TB 190

TECHNICAL BULLETIN

For the Attention of:	Platform Lift Installers
	Platform Lift Trade Customers
	Technical Support Engineers
Date:	12 th December 2022
Product:	Stannah Midilift XL+
Subject:	Control unit front panel earth tab

Figure 1

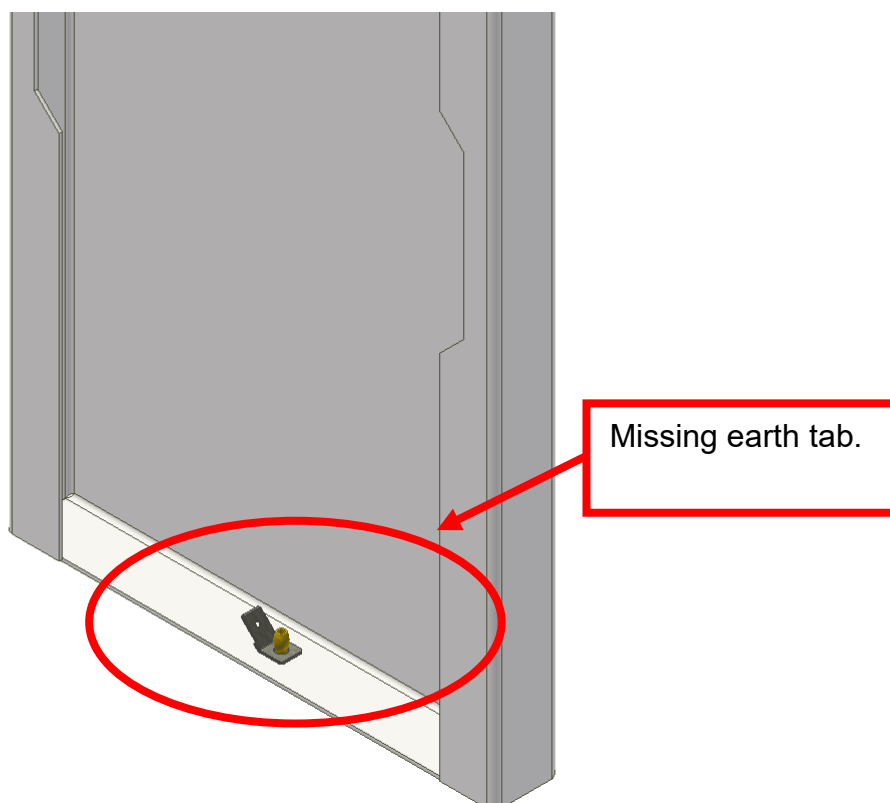
It has become apparent that some XL+ upper landing control unit front panels have been assembled without the earth stud (see Figure 1). If this panel remains unearthed there is an increased risk of an electric shock.

If inspection of the control panel confirms that no earth tab has been fitted an earth tab retrofit kit can be ordered through Stannah lifts spares department under part number 950531.
